## AIA® Document G701™ - 2001

## Change Order

<b>PROJECT</b> (Name and address):	<b>CHANGE ORDER NUMBER:</b> 001	<b>OWNER:</b> <input checked="" type="checkbox"/>
George Memorial Library Renovation	<b>DATE:</b> October 2, 2013	<b>ARCHITECT:</b> <input checked="" type="checkbox"/>
1001 Golfview Drive		<b>CONTRACTOR:</b> <input checked="" type="checkbox"/>
Richmond, Texas 77469		<b>FIELD:</b> <input type="checkbox"/>
<b>TO CONTRACTOR</b> (Name and address):	<b>ARCHITECT'S PROJECT NUMBER:</b> 1239	<b>OTHER:</b> <input type="checkbox"/>
Crain Group, L.L.C.	<b>CONTRACT DATE:</b> November 13, 2012	
2635 Miller Ranch Road	<b>CONTRACT FOR:</b> Design-Builder	
Pearland, Texas 77584

**CHANGE ORDER 8**  
**GEORGE MEMORIAL LIBRARY RENOVATION**  
**1001 CLOVERLEAF DR.**  
**RICHMOND, TEXAS**

### Handrail around circulation desk

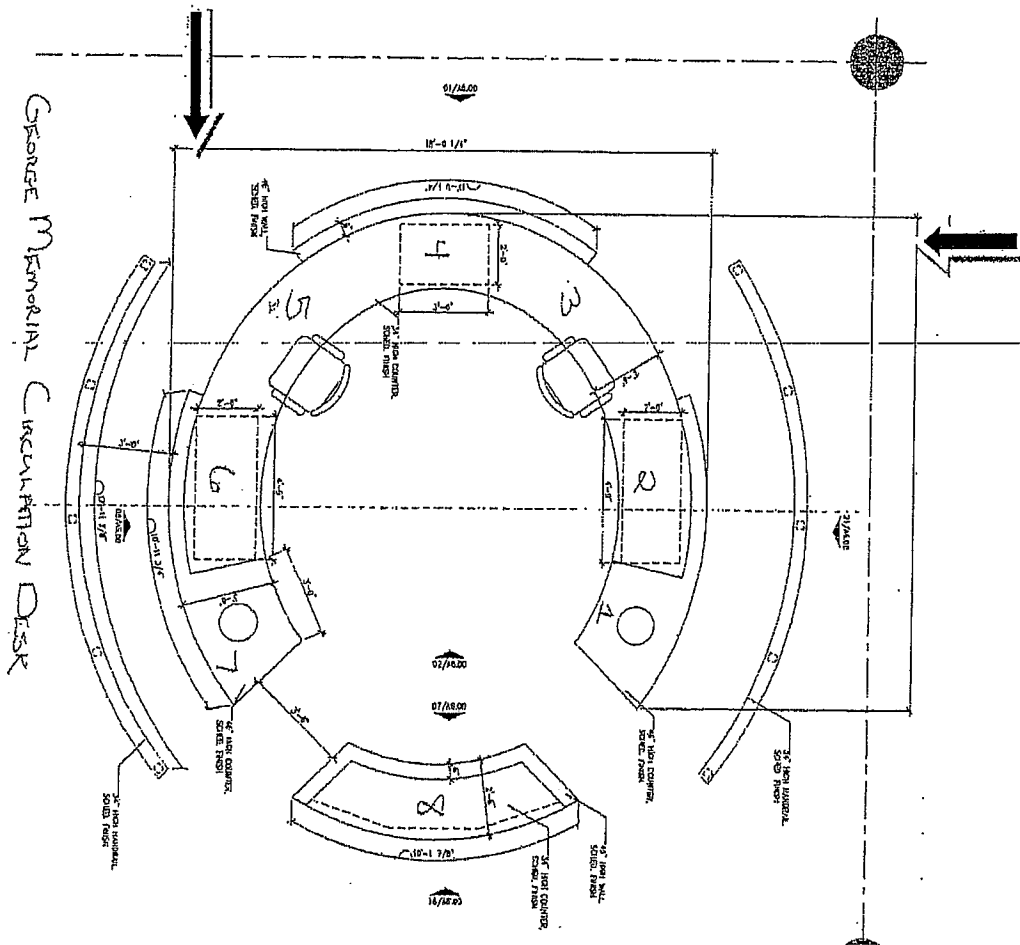
Arrows indicate handrails for customer queuing. Handrails are **NOT** a part of this scope but shown here for information purposes only. Above drawing also shows the desk having barrier walls in sections on the top of the granite work-surface. Owner does **NOT** want this feature. Use this drawing for overall dimensions; please alert Owner to any deviations to the overall sizing as this will affect the placement of the power/data conduits in Modules 1 and 7. See supplemental drawings for module detail and side cut views.

# Front BEND Country LIBRARIES CIRCULATION DESK

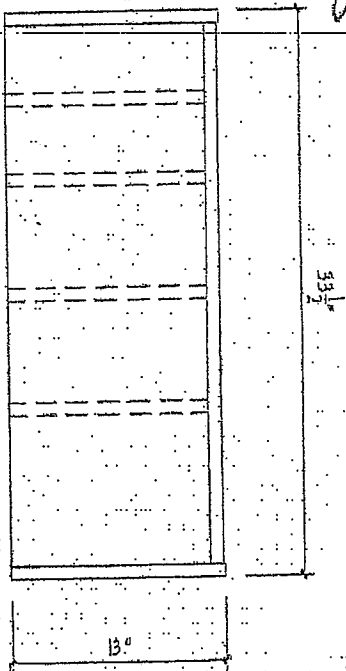
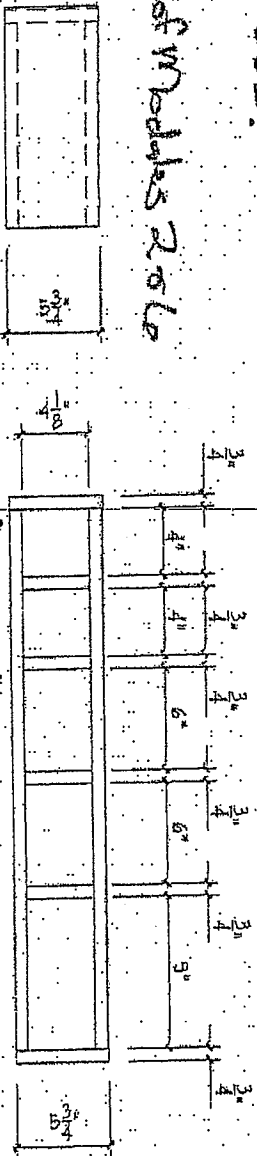
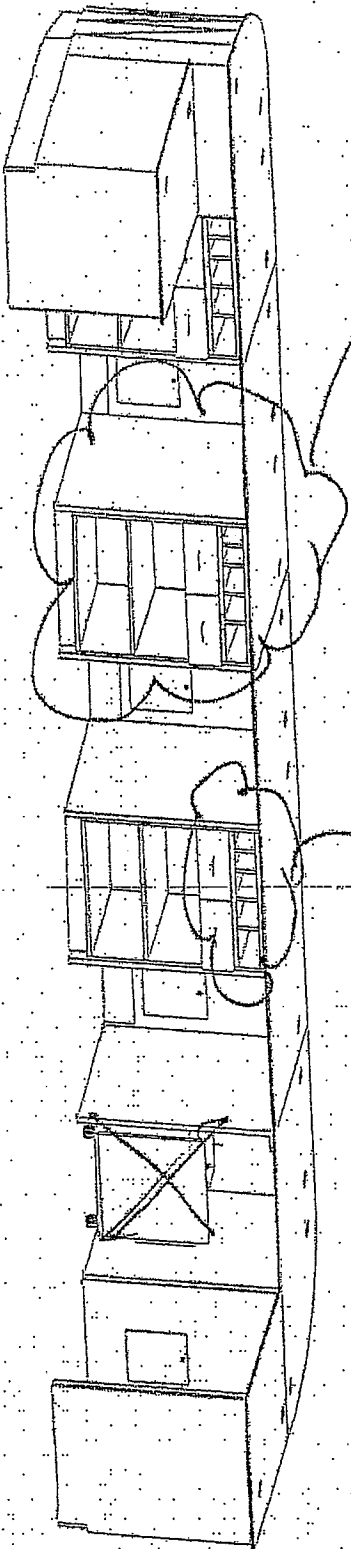
See ~~written~~ Specs for specific dimensions & shape!

The proposed circ desk is circular - Refer to house drawing in written specs.

# Fort Bend County Libraries Circulation Desk

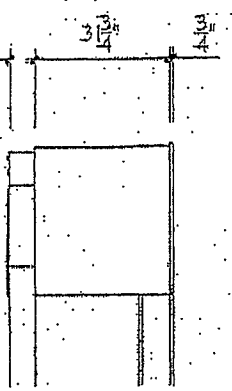
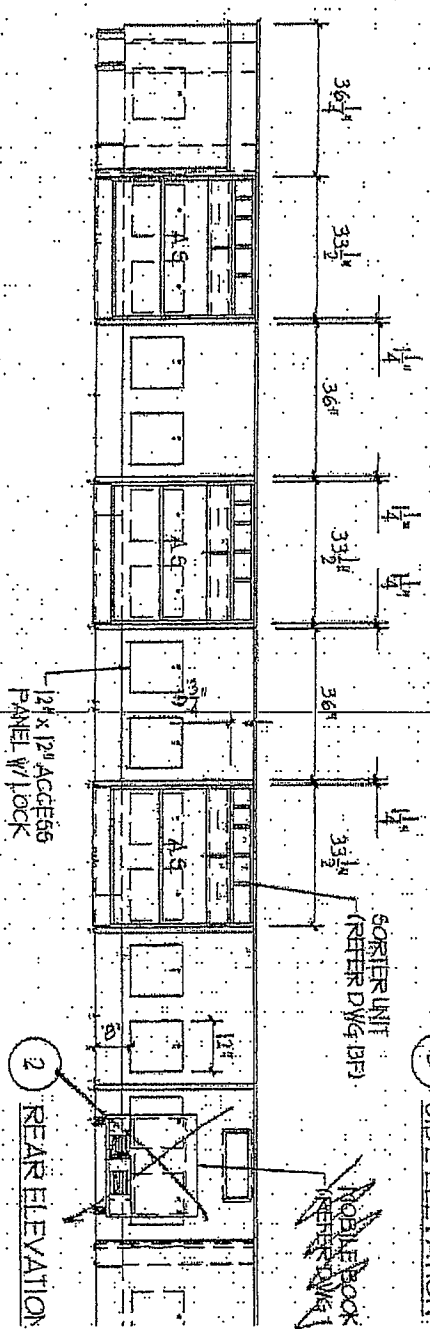
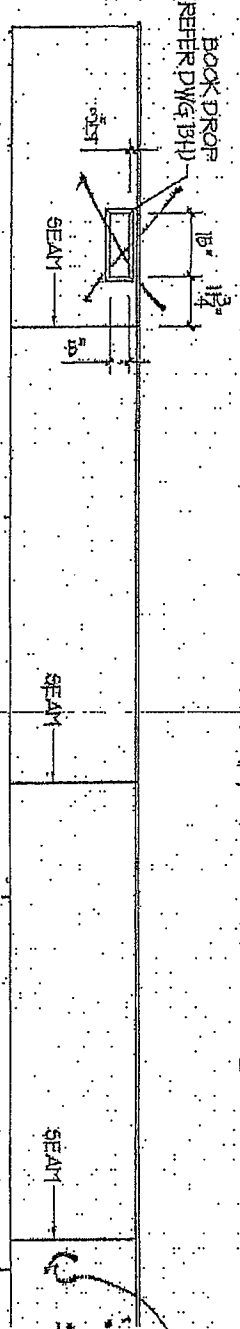
Note: There is NO backdrop in proposed circ desk

See Specs for actual dimensions & shape

In your drawings indicate where seams will go/be placed.

Side View of Modulo

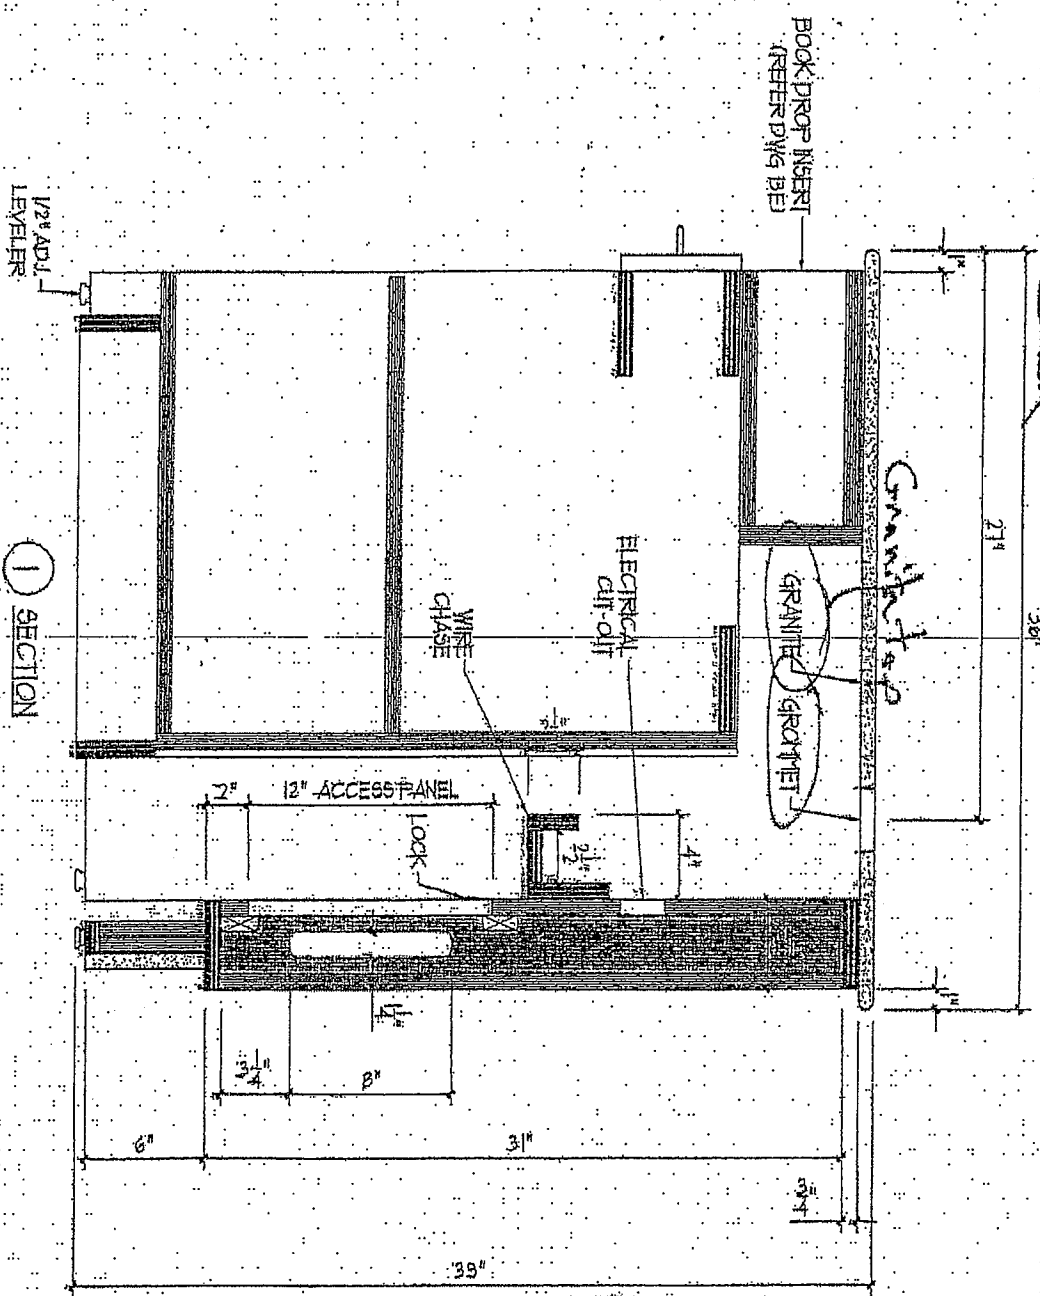
See Miller  
Specs for  
specific dimensions.  
Do not use this  
drawing.

Side View of Model 3615

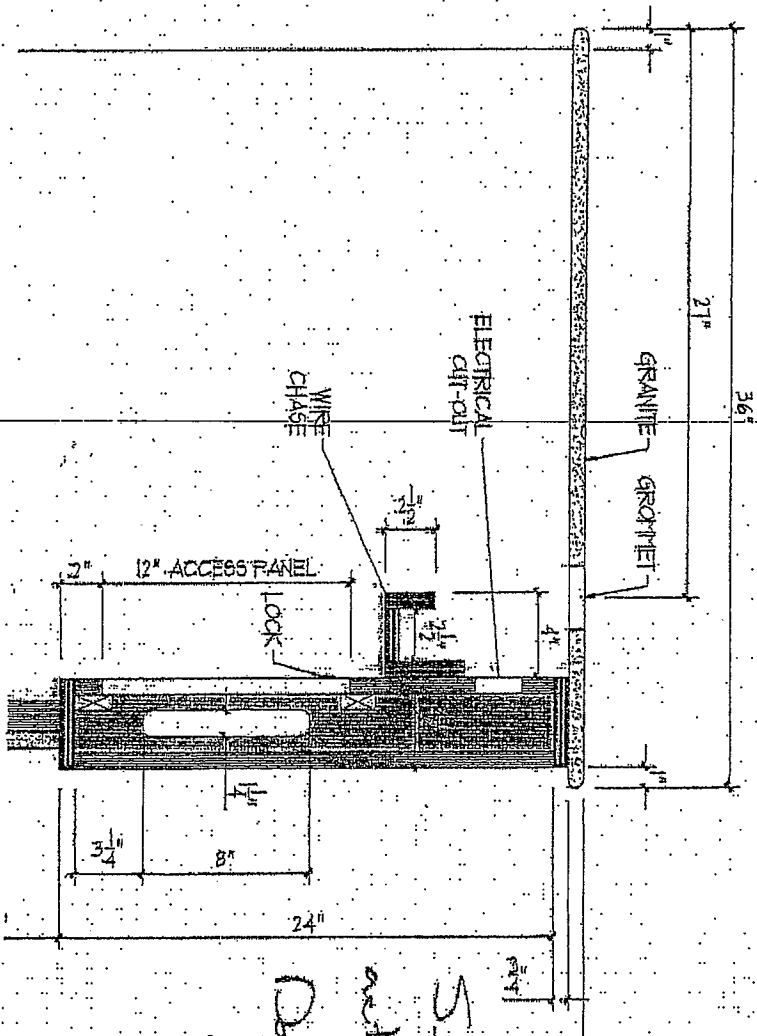
Do not use this  
drawing.  
with  
5 on 5 spec for  
actual dimensions
